Annexure A

Pavillion Residences No 3 Pty Limited v Northern Beaches Council

Amended Plans and Documents

PROJECT TITLE: RESIDENTIAL DEVELOPMENT
21 WHISTLER ST MANLY

DRAWING TITLE: NORTH ELEVATION

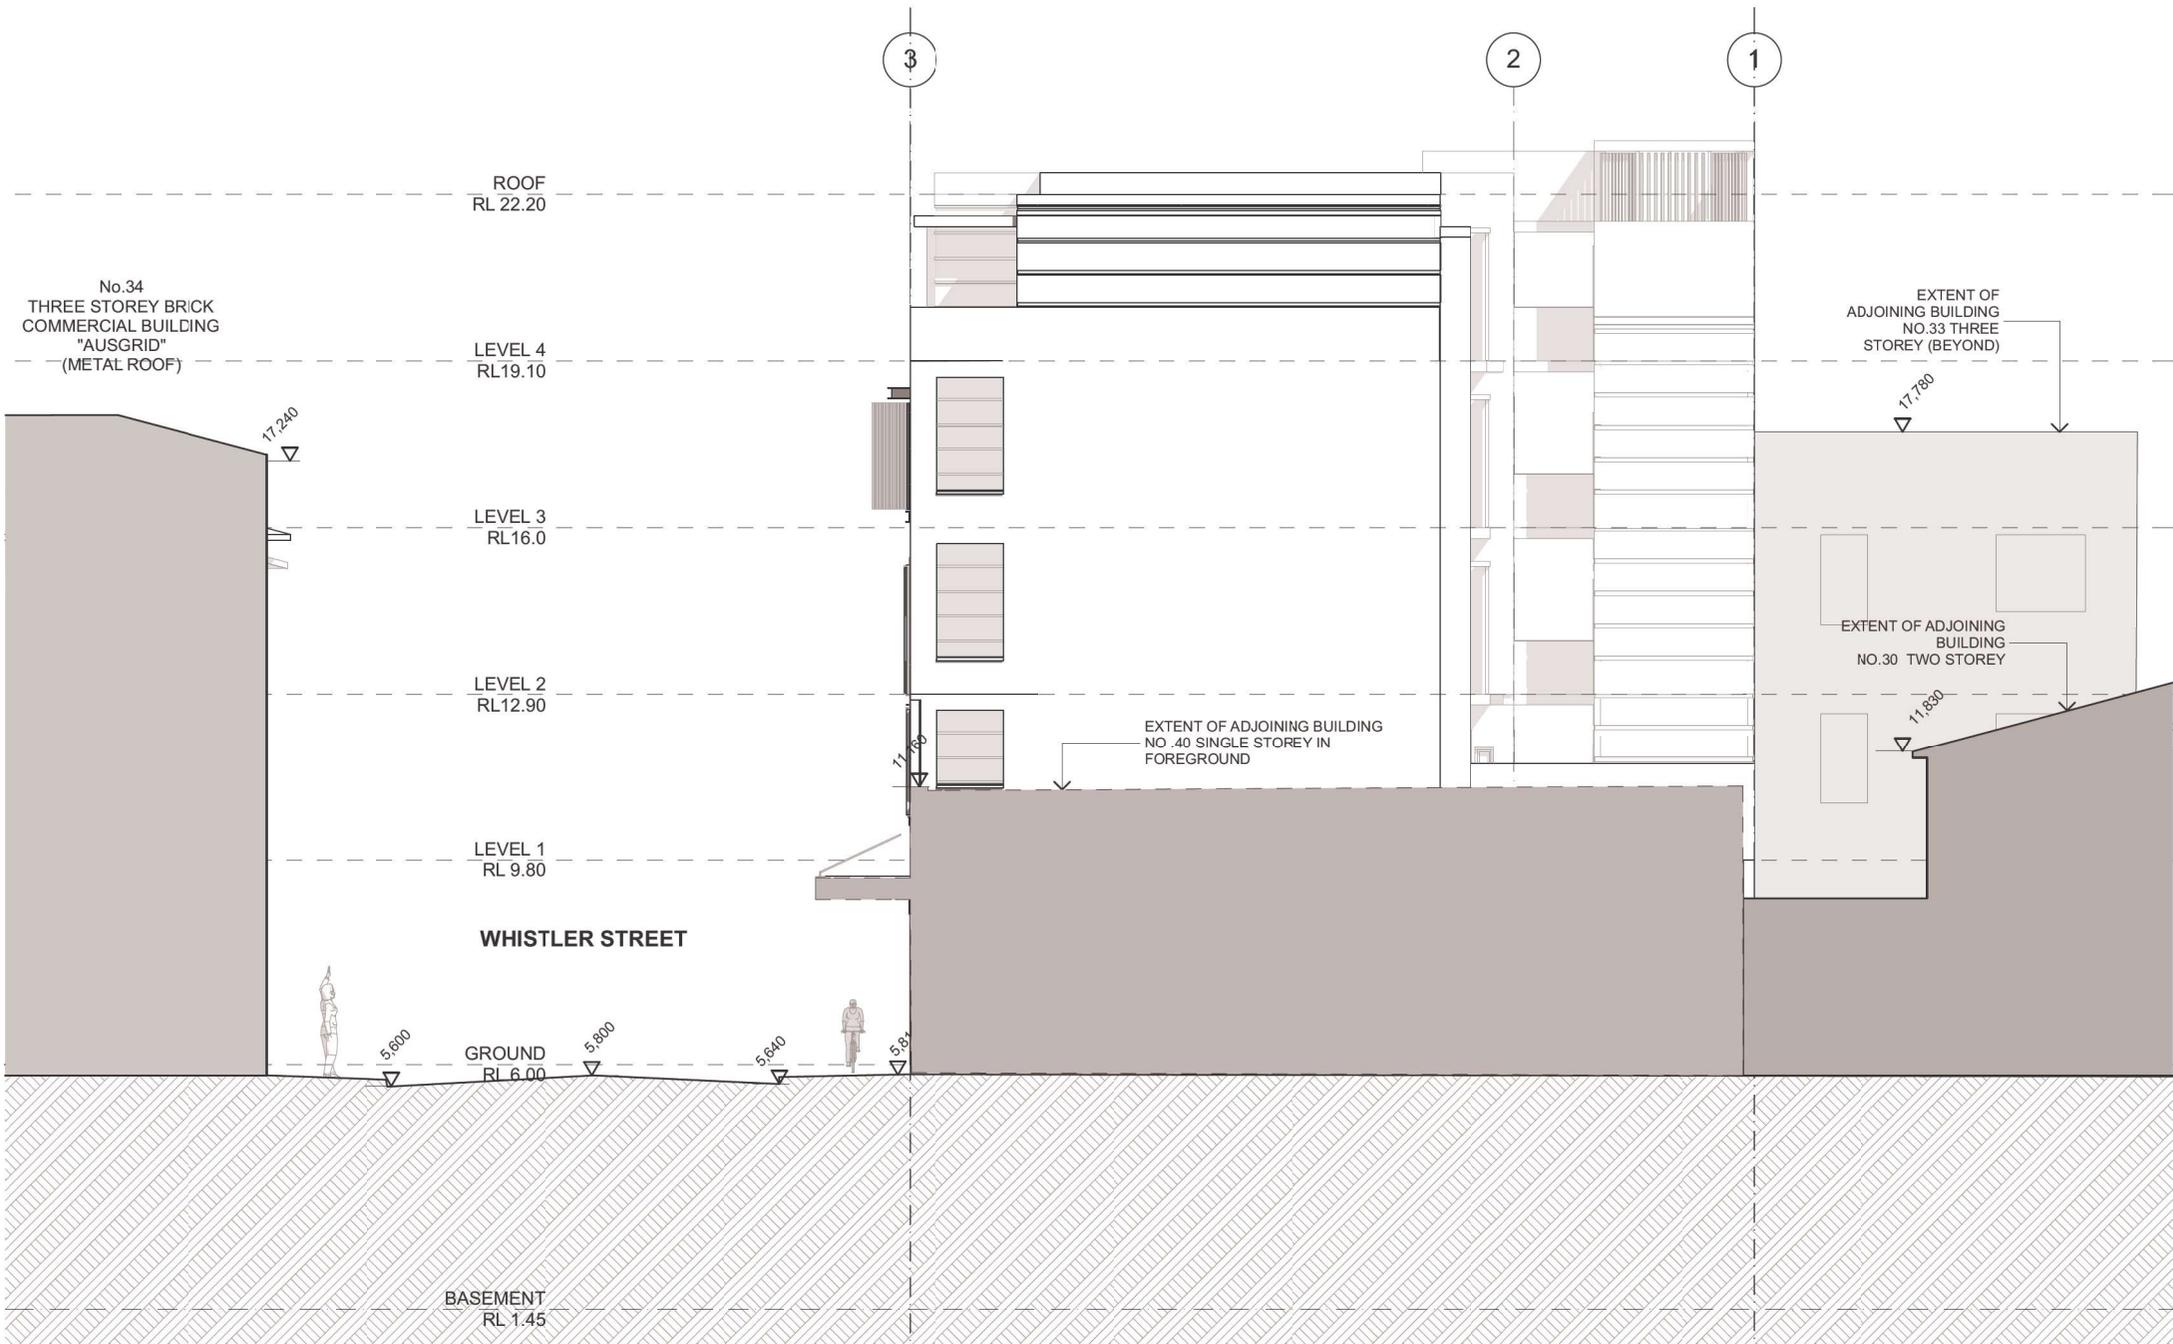
DATE	REV	DESCRIPTION
04/08/19	A	CHANGE OF STONE AT BASE REORGANIZATION OF WAITING BAYS AT STREET RECONFIGURATION OF STREET FACADE
05/02/20	B	LIFT + STAIR MIRRORED

DRAWING TITLE: SOUTH ELEVATION

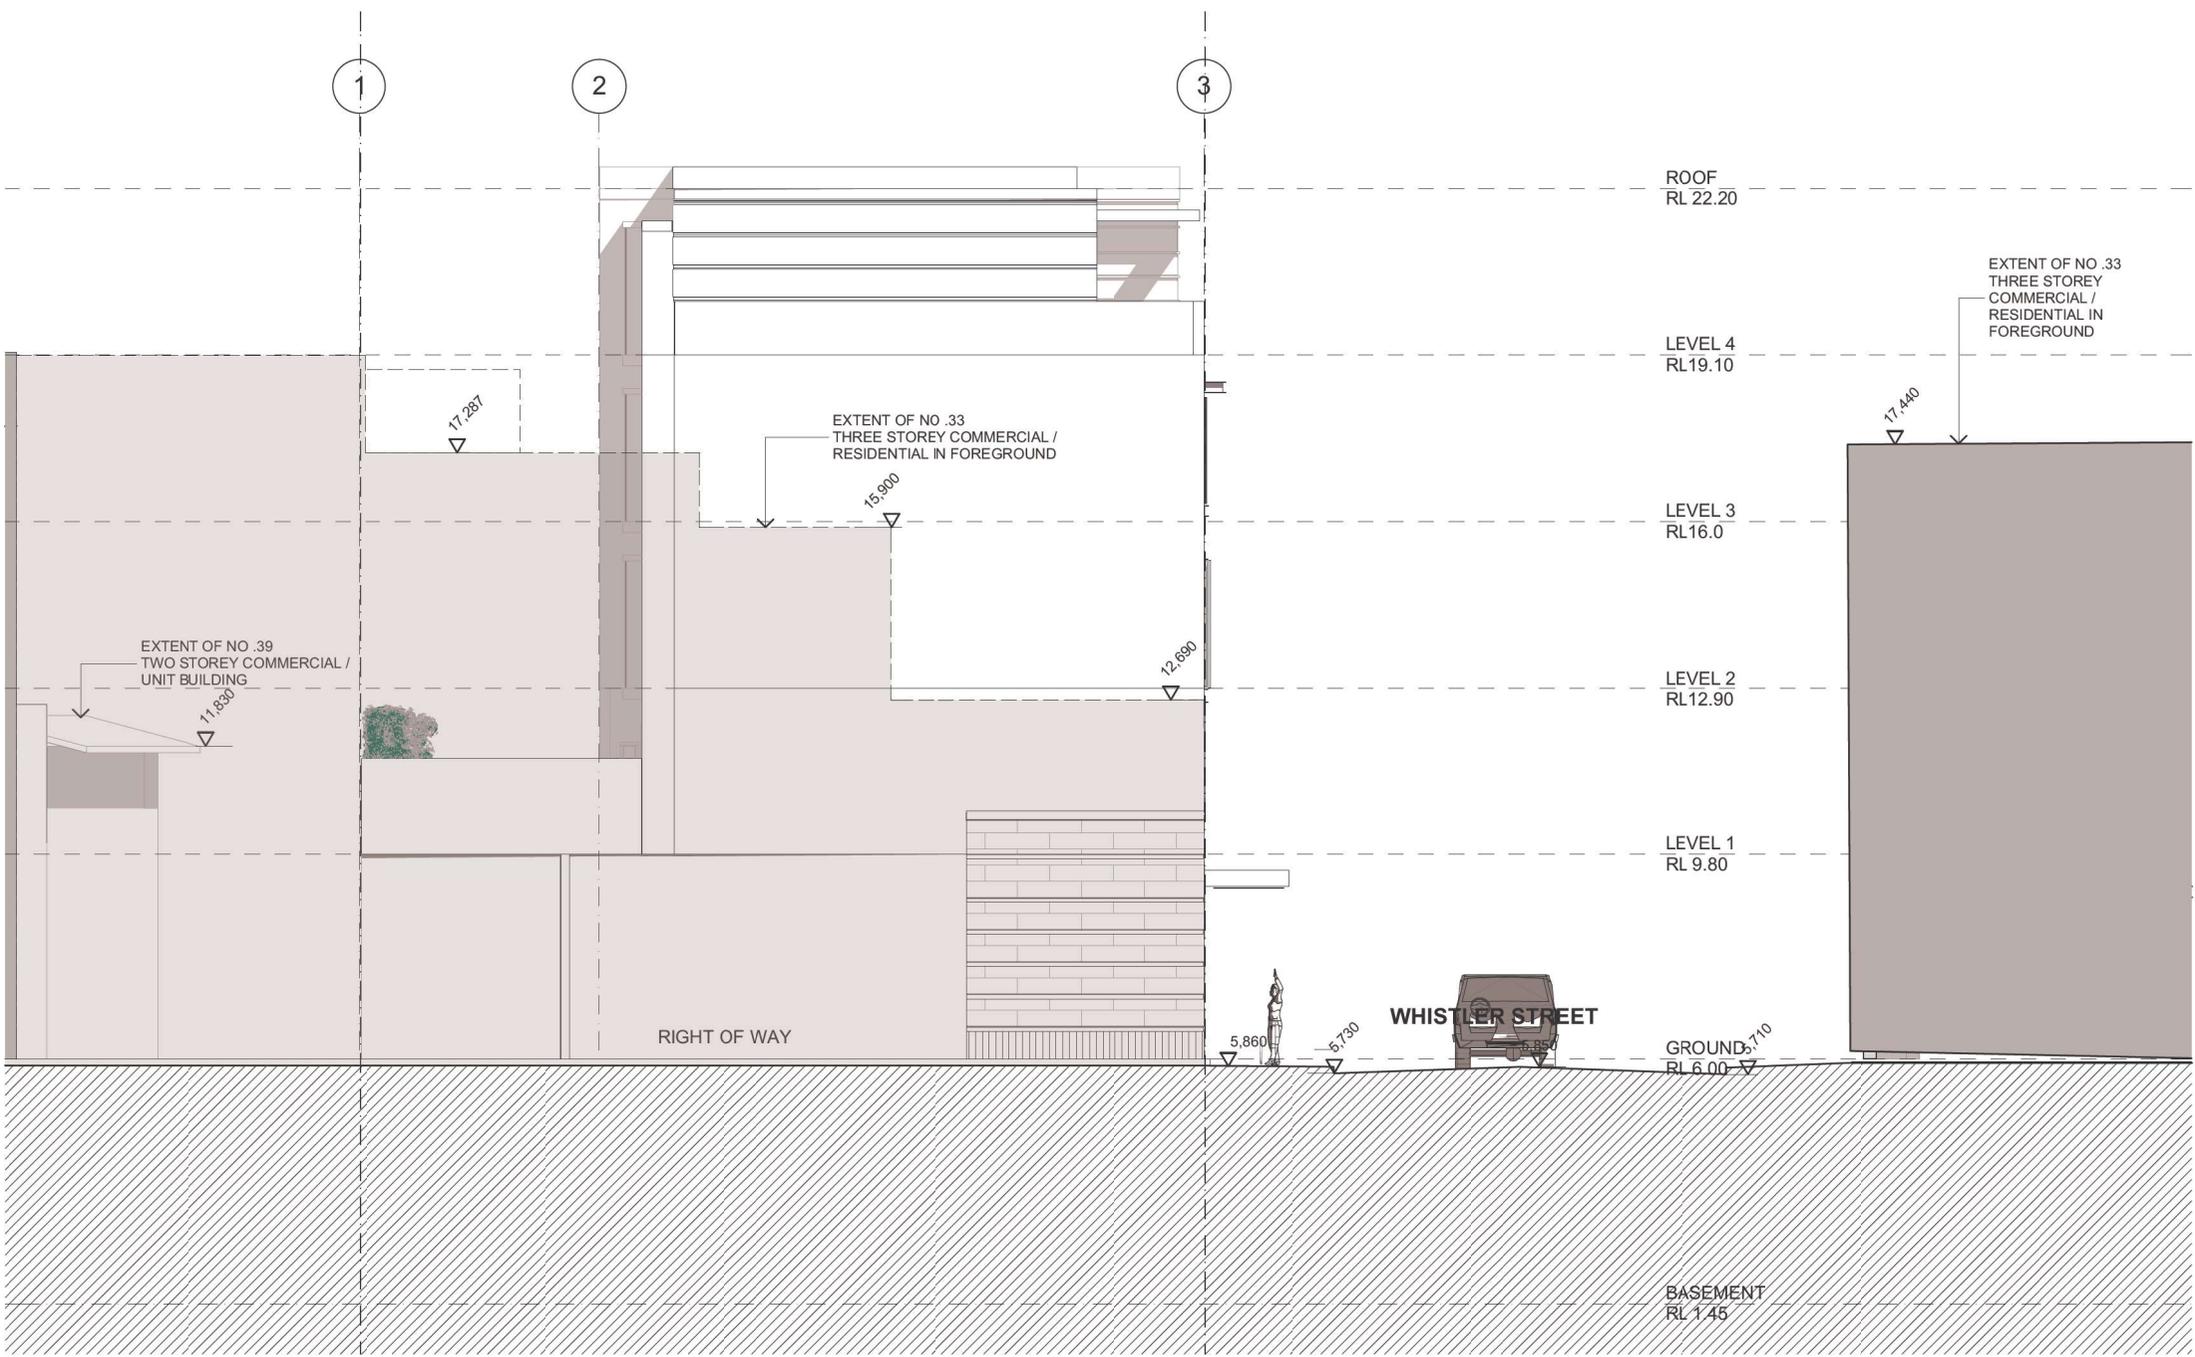
DATE	REV	DESCRIPTION
04/08/19	A	CHANGE OF STONE AT BASE REORGANIZATION OF WAITING BAYS AT STREET RECONFIGURATION OF STREET FACADE
05/02/20	B	LIFT + STAIR MIRRORED
